34 Diamond Street

APPLICATION FOR PERMIT TO ERECT  
SIGN OVER PUBLIC SIDEWALK OR STREET

# APPLICATION FOR PERMIT

CITY OF PORTLAND, MAINE  
IN THE BOARD OF APPEALS

Proposed Storage Tank Location  
Sango Shoe Mfg. Corp  
34 DIAMOND ST

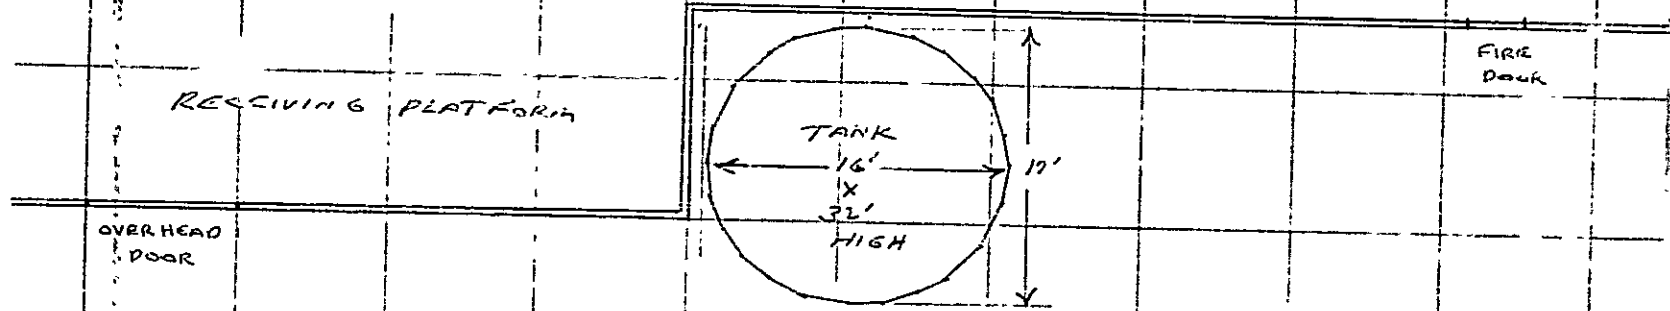
Received your letter as of this date giving us information on proposed storage tank you plan to erect at the above named location. It will be necessary for you or the persons responsible for erecting this tank to apply for a building permit at this office before this department and the Fire Department can give their O.K. for the storage of this material and erection of this tank.

1. The distance of this tank from the existing building.
2. We will need to know what the foundation will be to support this structure.
3. We will need an elevation plan, as well as a certificate of design to be signed by a qualified designer who is willing to take the responsibility for this tank or have the manufacturer furnish the statement of design. Enclosed is a statement of design blank.

Type of material: Polyvinylchloride pellets total weight of material: 80,000 lbs. Tank type: Clindrical - welded steel tank dimensions: diameter 16 ft, height 32 ft.

Location of tank: See enclosed drawing.
